October 2020 Update Pack

Please update your March 2020, 4th Edition Handbook as follows:

Changes to the fourth edition following October 2020 update

7. Roof junction – pitched roof without room-in-roof

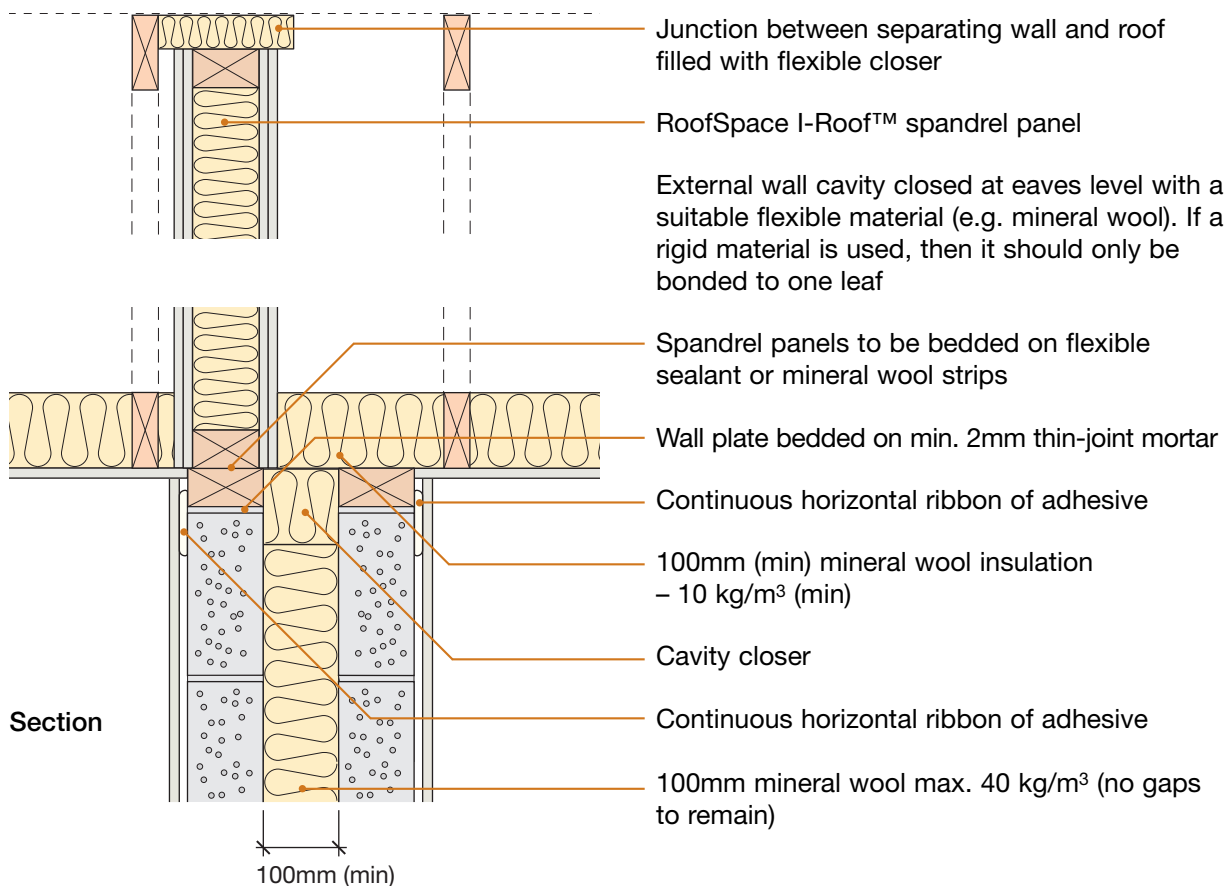
Diagram 7 5 Clarification given on sealing at the base of the spandrels.

8. Stepped roof junction – pitched roof without room-in-roof

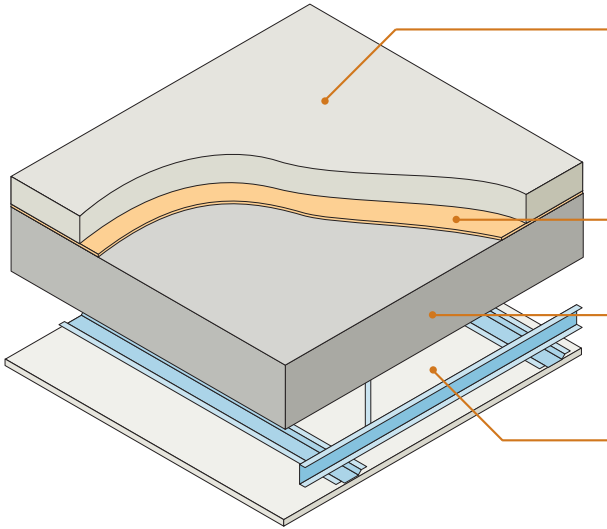
Diagram 8 6 Clarification given on sealing at the base of the spandrels.

8. Bonded resilient floor covering - installed over levelling screed, or direct to slab

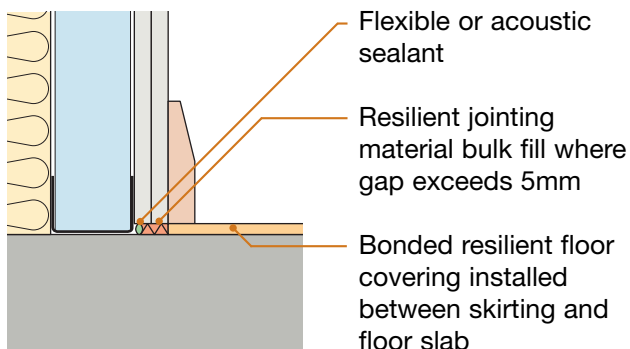
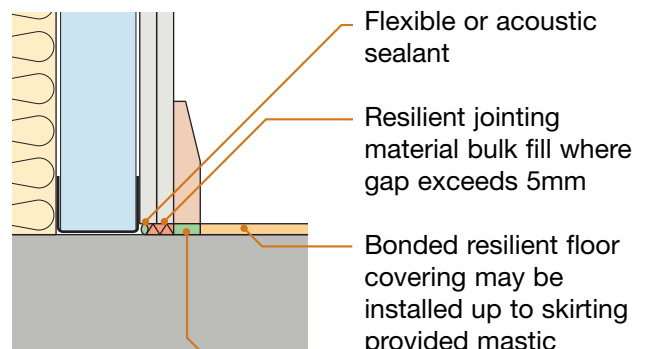
Diagram 8 5 Note added to clarify bonded layer can be applied to screed or structural slab.

Bonded resilient floor coverings can be applied over a levelling screed, or direct to the structural slab.

6. Underfloor heating systems below ScreedBoard®

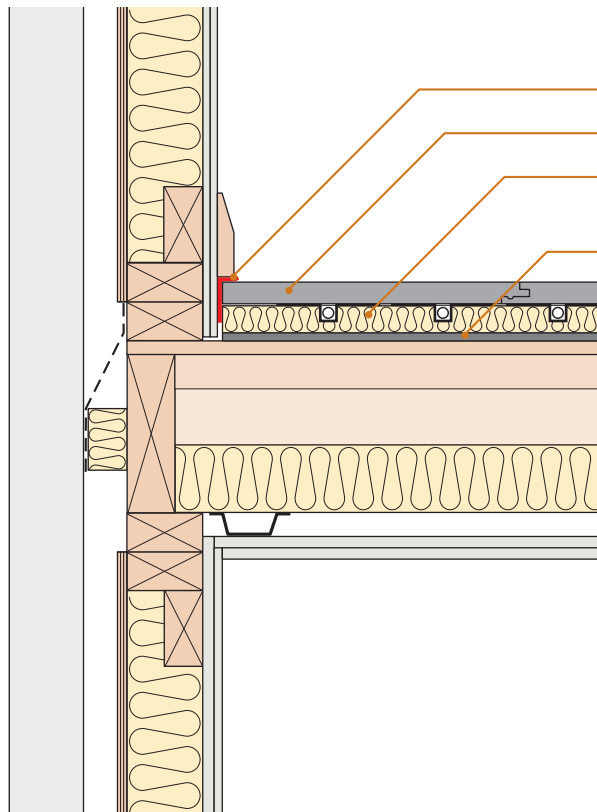
Diagram 6 5 *Collecta*® Mojave® added as an optional underfloor heating system.

- Collecta*® Mojave® S1-8 or S2-8 system;
or use the following components:
- YELOfon® FS50 flanking angle
- 20mm ScreedBoard® 20
- 25mm (min) extruded or expanded polystyrene panel with underfloor heating pipes
- 8mm *Collecta*® FIBREfon® 8 resilient layer

10. Underfloor heating systems below ScreedBoard®

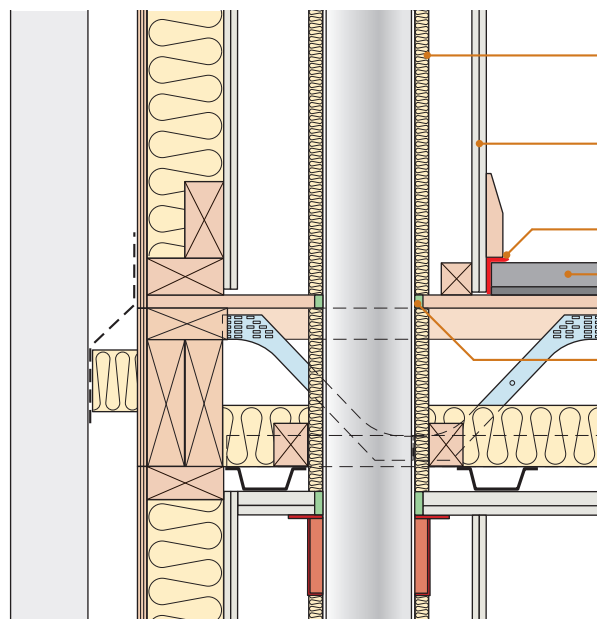
Diagram 10 7 *Collecta*® Mojave® added as an optional underfloor heating system.

- Collecta*® Mojave® S1-8 or S2-8 system;
or use the following components:
- YELOfon® FS50 flanking angle
- 20mm ScreedBoard® 20
- 25mm (min) extruded or expanded polystyrene panel with underfloor heating pipes
- 8mm *Collecta*® FIBREfon® 8 resilient layer

5. Underfloor heating systems below ScreedBoard®

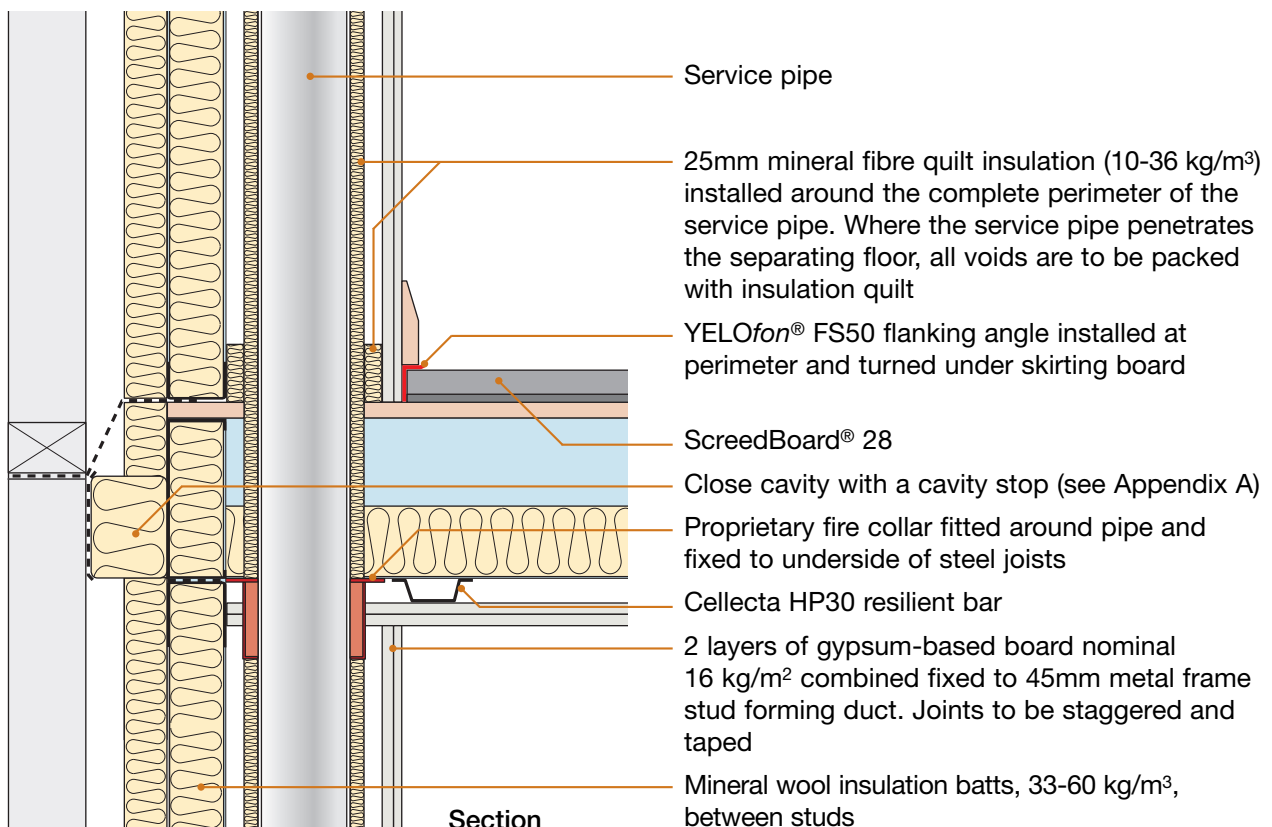
Diagram 5 5 *Collecta*® Mojave® added as an optional underfloor heating system.

Appendix A2 – Specific Flanking Conditions

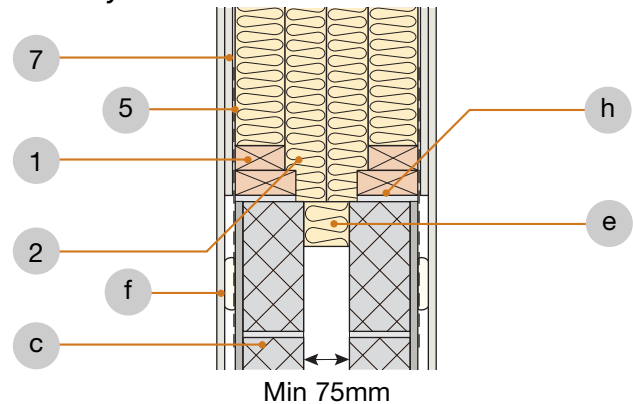
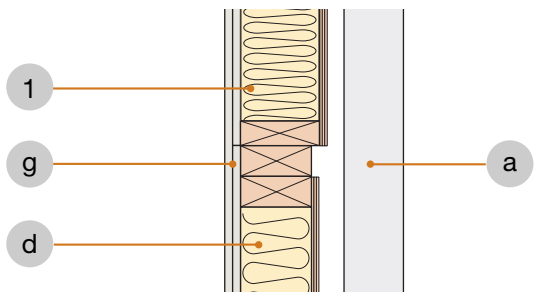
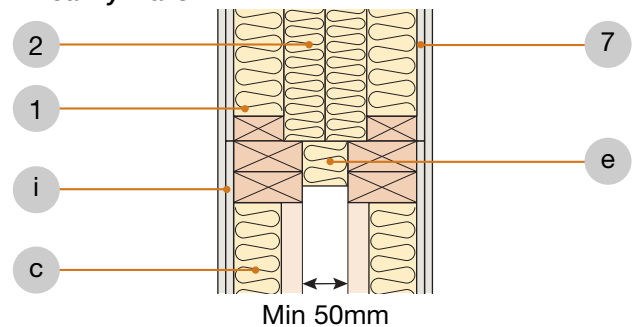
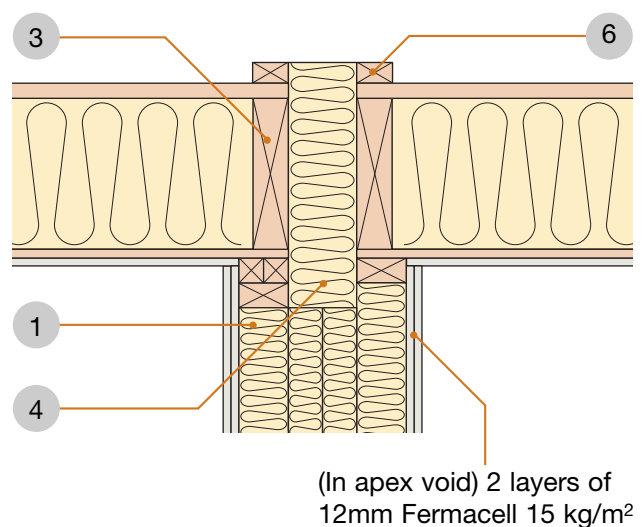
Smartroof 3 Timber framing details updated on spandrels and roof cassettes.
Cavity fill added as an option.
Item 7 added to clarify board specification.

- 1 Smartroof panel.
- 2 Breather membrane-encased insulation cushions butting together, fully filling the cavity (optional).
- 3 Smartroof roof panel.
- 4 125x300mm flexible cavity closer by Smartroof.
- 5 Vertical metal straps by Smartroof.
- 6 25x50mm counterbattens by Smartroof.
- 7 12mm Fermacell 15 kg/m².
- a Outer leaf of external wall.
- b Continue cavity batts up to gable end if required.
- c Refer to relevant **robustdetails®** separating wall.
- d Inner leaf dependent on Robust Detail being used.
- e Cavity closer.
- f Gypsum-based board dependent on Robust Detail being used.
- g Gypsum-based board nominal 8 kg/m². 2 layers required where separating floors are used (refer to **robustdetails®** separating floor).
- h 100x50mm wall plate on nominal 10mm mortar bed. Ensure no gaps remain.
- i 2 layers gypsum-based board total nominal 22 kg/m².
